SUNDRY NOTICES AND REPORTS ON WELLS
Do not use this form for proposals to drill or to re-enter an abandoned well. Use form 3160-3 (APD) for such proposals.

8. Well Name and No.
PURE GOLD MDP1 29-17 FED COM 171H

OXY USA Inc. respectfully requests to amend the approved drill plans with the following changes:

Oxy USA Inc. – Bulk Sundry
PURE GOLD MDP1 29-17 FED COM 171H, 172H, 173H, 174H and 175H

TMK UP TORQ™ DQW
Technical Data Sheet

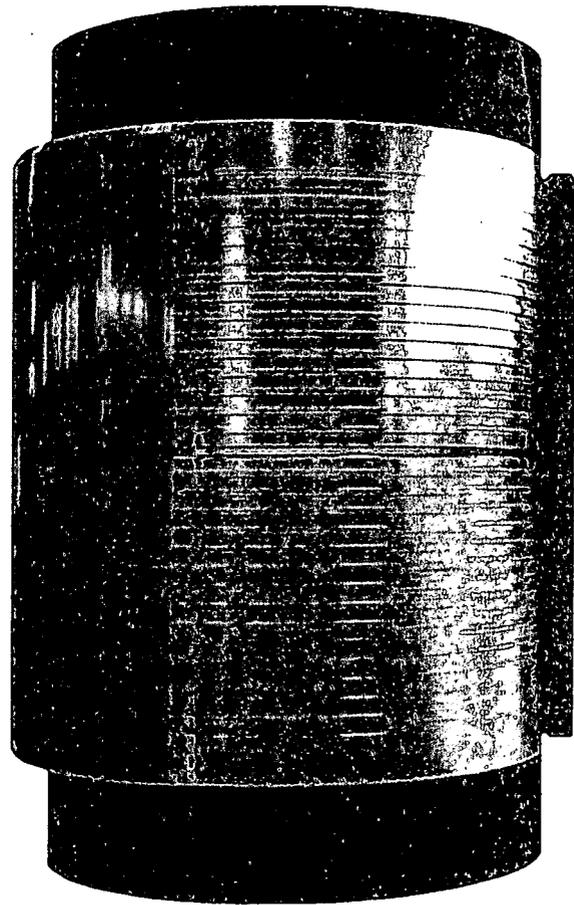
1. Changing 9-5/8" casing weight from 43.5ppf to 40ppf ?h
2. Changing Deep intermediate hole size from 8.5" to 8.75" ?h
3. Changed 7-5/8" SF from 4000" to 6000" ?h
4. Updated cement calculations based on new casing and hole sizes
5. Option to run production casing with DQW TORQ connections to accommodate hole conditions
6. Option to cement 9-5/8" and/or 7-5/8" intermediate strings offline (now in drill plan)

*Oxy requests the option to run production casing with DQX, SF TORQ, and/or DQW TORQ connections to accommodate hole conditions or drilling operations.
